Report No. FAA-RD-71-104

INTERMEDIATE ACTIVITY LEVEL TOWER CAB EVALUATION-PHASE II

J. Roy Bradley, Jr.
National Aviation Facilities Experimental Center
Atlantic City, New Jersey 08405

DECEMBER 1971

FIGURE 2 - NAFEC TOWER CAB LABORATORY

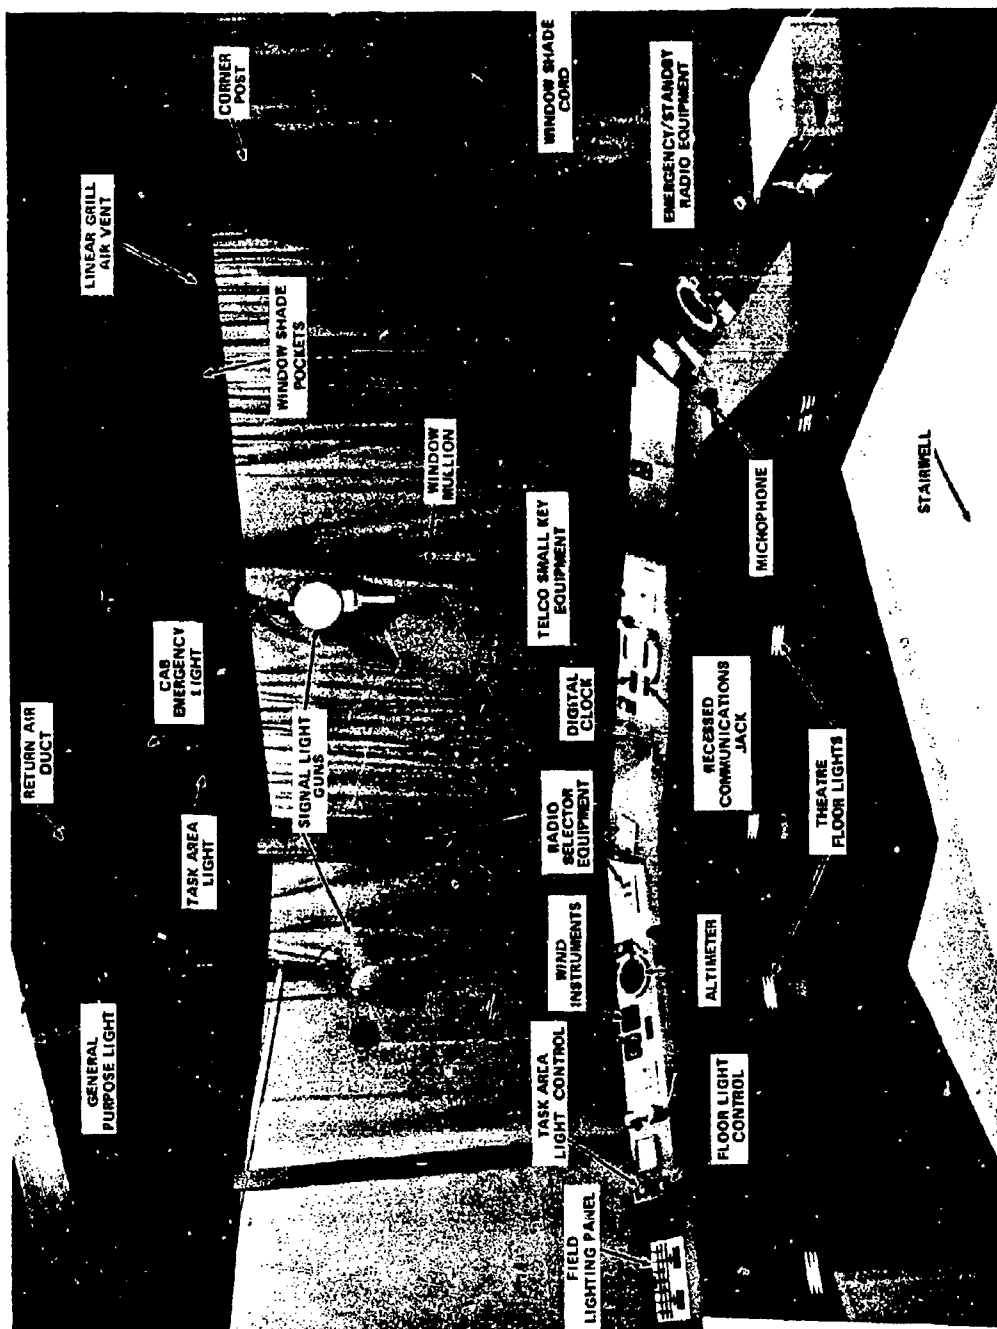
The Tower Cab: The tower cab is six-sided, has a 10-foot clear ceiling space, vertical walls to the window sill, and the windows slope outward at 15°. As shown in Figure 2, the tower cab corner posts have a maximum cross-sectional dimension, as viewed from any angle, of 14 inches; while a similar measurement for the window mullions is 4 1/2 inches. It was noted that the tower cab size and shape satisfied operational requirements; however, concern was expressed over the comparatively large size of the corner posts and window mullions.

Light Systems: The position (console) lights consisted of six units, Lightolier Model 7051, that were recessed mounted in the ceiling (Figure 2) over the operators' console. Each lamp had its own "push-to-click" off/on switch and dimmer control located on the console equipment turret. The adequacy of the position lights and location of the controls were judged excellent. It was suggested that a "turn-to-click" off/on switch and dimmer control would preclude activating the lamp at a high-intensity setting, thereby extending the life expectancy of the bulb.

Consoles: The operators' console was developed in Phase I. The basic components consist of a small base unit, a 12-inch shelf and equipment turret. The console shown in Figure 2 has a writing surface 30 inches above the floor. This is considered a normal "sit" console. There is an 8-inch spacer component that may be provided as an option. The purpose of the spacer is to raise the shelf and equipment 8-inches higher for a "sit/stand" operation. FAA regions may order any combination of sit or sit/stand arrangement that suits individual regional requirements. The console is finished with a gingersnap colored, glare-free matte finished formica which was rated excellent.

FIGURE 4 - NAFEC TOWER CAB LABORATORY SHOWING JUNCTION
ROOM LEVEL AND TOWER CAB BASE

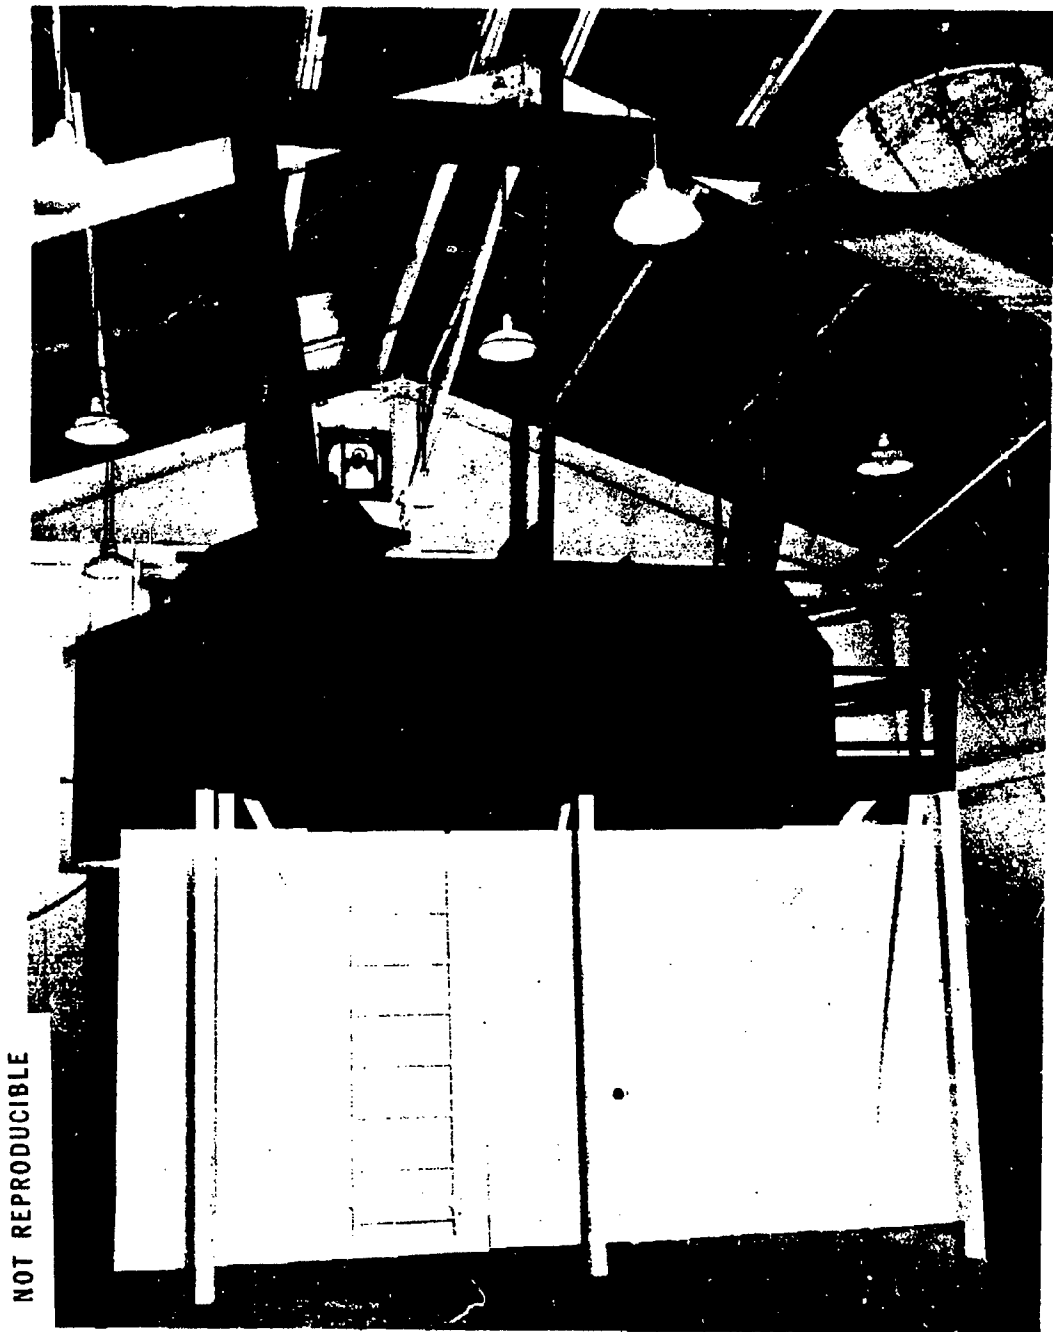
The Junction Room Level: The purpose of the junction room level (Figure 4), in addition to adding height to the tower structure, is to provide an area for a stairway to other levels, elevator shaft or storage room, water pipe chase, lavatory, ac and dc panel boards, equipment racks and clothes rack. The junction room level was rated as follows; stairs from the tower cab to the catwalk landing (Figure 6) and from this landing down to the junction room (Figure 7), very good. The stairs to the lower levels, although not mocked-up, met the standard codes for handrail safety. However, it was suggested that a wire mesh installation be included with the handrail as an added protection feature for facility personnel and visitors.
